DEVELOPMENT SERVICES
ENGINEERING DIVISION
156 S. BROADWAY, SUITE 150
TURLOCK, CA 95380

City Project No.: 17-53 (095)

Addendum No.: 1

Revisions to Plans and Specifications

C-5

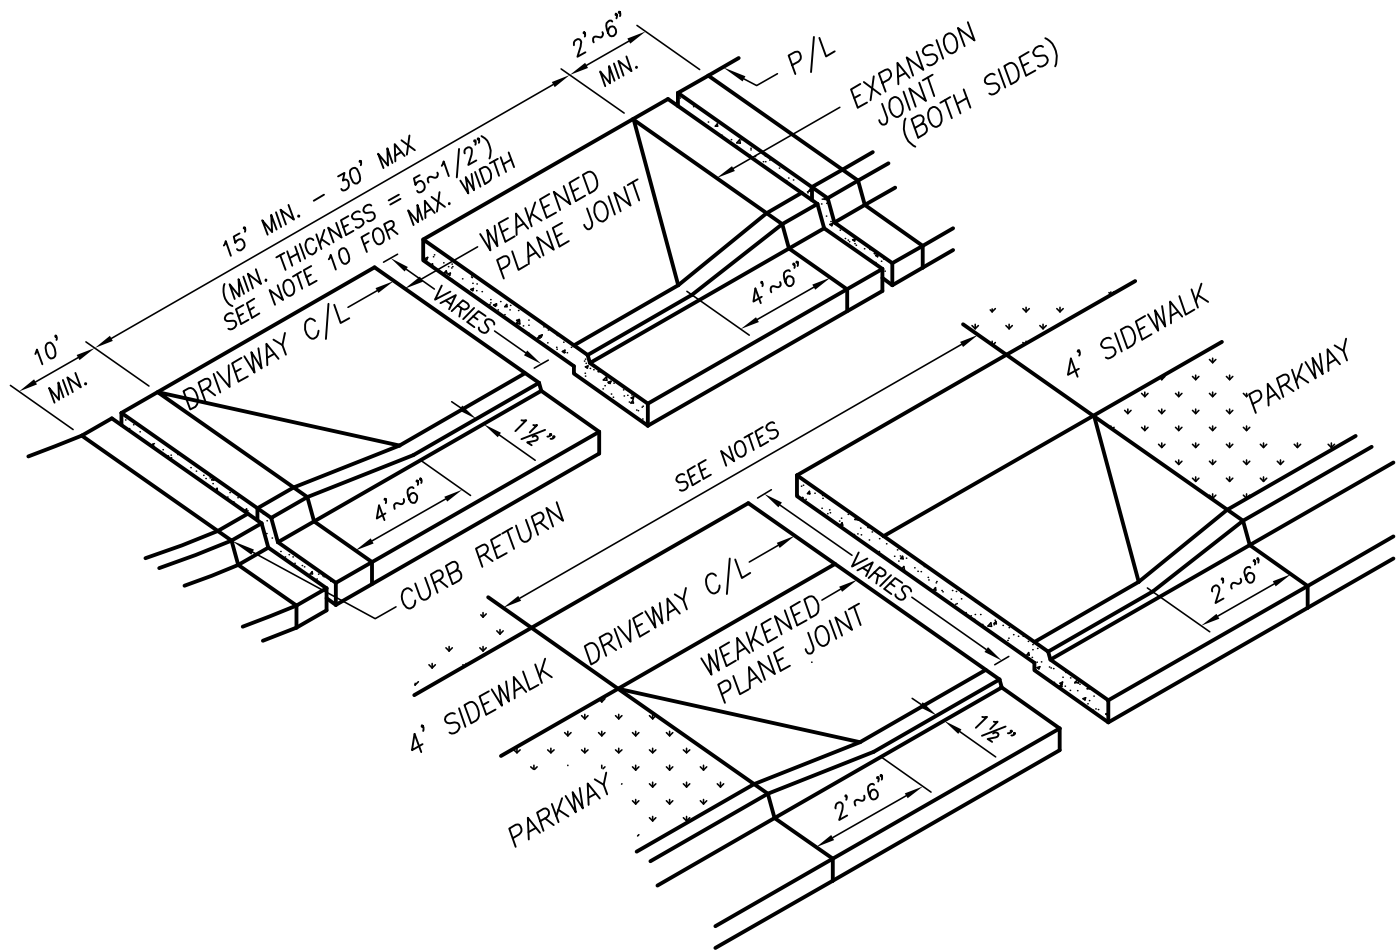
3. Can you provide City Detail C-5?
 - a. City Detail C-5 is attached to this Addendum.
4. Please clarify the concrete to use; Section 8.01 calls out Minor Concrete but the Concrete Notes on the install drawings call out a 6-sack mix.
